Bulletin #: TB970701 Parachute Swivel De-burring Date: 7/3/97 Page 1 of 1

Inspection / Service Requirement:

Parachute Swivel

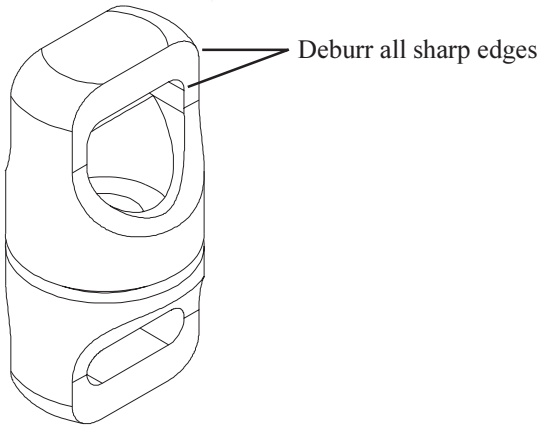
A number of early model parachute swivels were produced with sharp edges which could cut the parachute bridle webbing during a deployment. (The swivel pictured below is the later model, which is not subject to this problem). Early model swivels are aluminum colored, while later models are anodized blue. Not all aluminum colored swivels are subject to this problem, but all swivels which are subject are aluminum colored.

To inspect your swivel, pull the webbing towards the side of the slot and feel the edges along the top of the slot. If they feel sharp, you need to debur these edges, and also the edges in the corners and on the sides of the webbing slots with a small file. It is not necessary to remove the bridle to do this. You should inspect the bridle during this process for any sign of damage.
